Project	<b>IEEE 802.16 Broadband Wireless Access Working Group</b> < <a href="http://ieee802.org/16">http://ieee802.org/16</a> >	
Title	Security Association Establishment for PKMv2-EAP	
Date Submitted	<b>2005-01-24</b>	
Source(s)	Mi-young Yun Jung-mo Moon Chulsik Yoon Young-jin Kim, ETRI 161, Gajeong-dong, Yuseong-Gu, Daejeon, 305-350, Korea	Voice: +82-42-860-4821 Fax: +82-42-861-1966 <a href="mailto:myyun@etri.re.kr">myyun@etri.re.kr</a>
Re:	Contribution to P802.16e/D5a	
Abstract	We propose to add and modify the EAP authentication and key distribution mechanism in the current TGe document on the basis of PKMv2-EAP mechanism.	
Purpose	Adoption	
Notice	This document has been prepared to assist IEEE 802.16. It is offered as a basis for discussion and is not binding on the contributing individual(s) or organization(s). The material in this document is subject to change in form and content after further study. The contributor(s) reserve(s) the right to add, amend or withdraw material contained herein.

# Security Association Establishment for PKMv2-EAP

Figure 5. Proposed PKMv2-EAP-only mode authentication

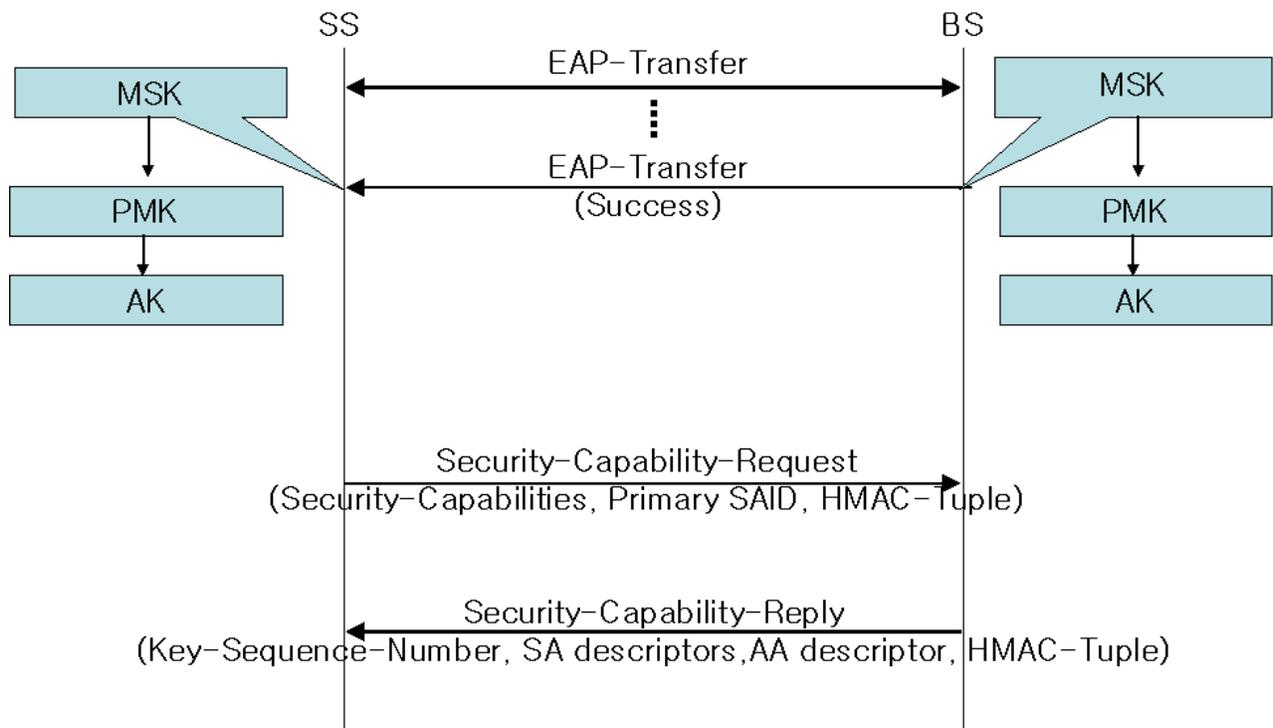
To provide an integrated and consistent way applying for various types of security modes, we propose PKMv2 EAP-only mode authorization flow and the AK derivation mechanism. To complete the EAP-only mode authentication and fast handover between the SS and the BS, it is necessary for the SS and the BS to exchange the SS's security and ciphersuite capabilities, and SA-Descriptor attributes. This information is the same as in Authorization and EAP-Establish-Key messages. It is one way to make use of existing messages but PKM-EAP adopts 3-way message handshaking. So, it is not useful for this purpose.

Accordingly, we define Security-Capability-Request and Security-Capability-Reply messages which can be validated by MAC Tuple.

The EAP-only mode authentication flow with Security -Capability messages is shown in Figure 5.
